23 June 2017

WRL Ref: WRL2017018DJA L20170623

## **Hume Coal Project SSD 15\_7172: Peer Review of Conceptual and Numerical Modelling that Predicted Likely Groundwater Impacts**

**Figure 17: A Common Problem with Numerical Models of Surface-Water Groundwater Interaction**

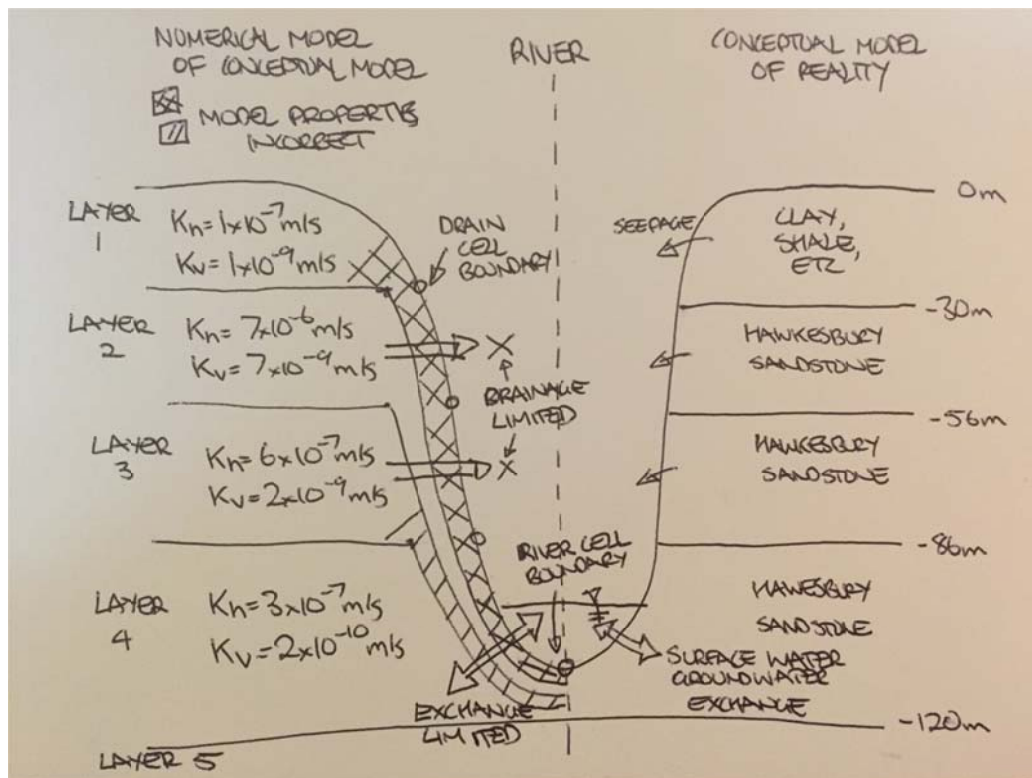
Figure 17 highlights that if this is not corrected:

- a. predictions of drainage to escarpments can be artificially limited;
- b. predictions of surface water – groundwater interactions can be limited;
- c. model calculations may become unstable near river boundary conditions due to alternating high and low values of properties in adjacent model cells;
- d. modellers may struggle to achieve model calibration with symptoms including:
  - a. problems with convergence and mass balance errors;
  - b. incorrect reductions to groundwater recharge to achieve calibration to heads;
  - c. incorrect alterations to the properties of deeper aquifer layers because groundwater flow in those model layers becomes incorrectly sensitive to the properties in the overlying shallow aquifers and aquitards;

This common modelling limitation can be readily corrected by copying the correct hydraulic properties to the model cells in the vicinity of the streams, however, this does require a model with spatially variable hydraulic conductivity and storage values assigned in every layer of the model around all surface water depressions in the landscape.
